# UNITED STATES PATENT AND TRADEMARK OFFICE

APPLICATION NO.	FILING DATE	FIRST NAMED INVENTOR	ATTORNEY DOCKET NO.	CONFIRMATION NO.
10/598,232	08/22/2006	Anthony Wlodarczyk	11348-023-999	1519
20583	7590	11/23/2009		
JONES DAY 222 EAST 41ST ST NEW YORK, NY 10017			EXAMINER VARNUM, RYAN A	
			ART UNIT	PAPER NUMBER
			3751	
			MAIL DATE	DELIVERY MODE
			11/23/2009 PAPER

# Office Action Summary

### **DETAILED ACTION**

## Annotated Fig. 2

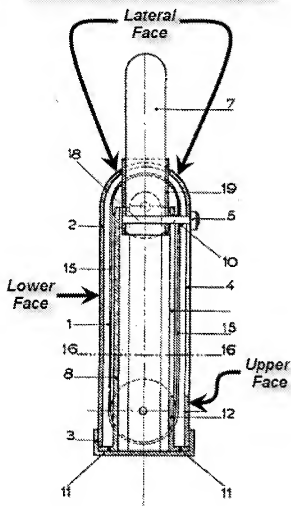
7. In re Claims 11, 12 and 22, Pecq discloses a device capable of being used as a writing implement comprising: a body 2 (Fig. 1) having an opening (See Fig.'s 1 and 2, the opening sealed by surface 1 in Fig. 1 and penetrated by writing tip 7 in Fig. 2) through which a writing tip 7 ("make up stick"; Fig. 2; Para 2, Line 4) passes along a longitudinal direction (See Fig. 2), and a slot 4 (Fig.'s 1-2) extending approximately along the longitudinal direction (Fig.'s 1-2); a support 19 ("tube carry make up"; Fig. 2; Para 2, Line 3) on which the writing tip is mounted (See Fig. 2), said support being

placed inside said body (See Fig. 2); a strip 1 ("foil"; Fig.'s 1, 2 and 5; Para 7, Line 1) comprising a first portion fixed to said support (See Fig. 2; it being seen that the strip 1 is fixed to support 19 by way of stud 18; Para 2, Lines 1-4), a central portion and an end portion guided along a curved path (See Fig.'s 2, 3 and 5; it being seen that the strip 1 has an end and a central portion; and the curved path being defined by the space between rollers 6 and the body 2), said strip being flexible (Para 7, Line 1 to Para 10, Line 2) and capable of being moved between two positions (See Fig.'s 1-2), namely a writing position in which said strip gives access to the opening (See Fig. 2) and a stowing position in which said strip closes off the opening (See Fig. 1); and a button 5 (Fig.'s 1-2) connected to said support (See Fig. 2), said button being capable of being moved along the slot between a distal position relative to the opening, for which said support and said strip are in the stowing position (See Fig. 1), and a proximal position relative to the opening, for which said support and said strip are in the writing position (See Fig. 2); wherein said body includes a lower face and an upper face connected together by at least one lateral face having a small height so as to produce a writing implement having a substantially flat shape (See Annotated Fig. 2 below), and wherein the slot 4 (Fig.'s 1-2) is made in the upper face (See Annotated Fig. 2 below), and the opening is made in the lateral face (See Annotated Fig. 2 below) along which the end portion of said strip moves between the writing position and the stowing position (See Fig.'s 1-2); the end portion of said strip possesses an oblong window 15 (See Fig. 5) which, in the writing position, is positioned so as to face the opening for the passage of the writing tip (See Fig. 2).

8. In re Claims 13-15 and 17-19, Pecq further discloses said button 5 (Fig.'s 1-2) is connected to said support 19 (Fig. 2) by a lug 18 ("stem"; Fig. 2) passing through the slot 4 (Fig. 2), the lug being fixed by a tongue 18 ("stem"; Fig. 2) perpendicular to the first portion of said strip (See Fig. 2; it being seen that the stem 18 serves the function of both a lug for holding the button and a tongue for fixing the button to the strip); wherein

the lug, the tongue and said strip comprise a unitary member (See Fig. 2, it being seen that the three structures are assembled in engagement with one another); the upper and lower faces are substantially oval (See Fig. 1 and Annotated Fig. 2 above; it being seen that the faces of the device are substantially oval in the sense that they each have an oval end); said support butts against the internal wall 8 (Fig. 2) of said body during its displacement in the writing position (Para 3, Lines 2-3; "tube carry-make-up 19 in slides 8 in form"; it being understood that support 19 abuts the internal wall 8 as it slides along it to the writing position).
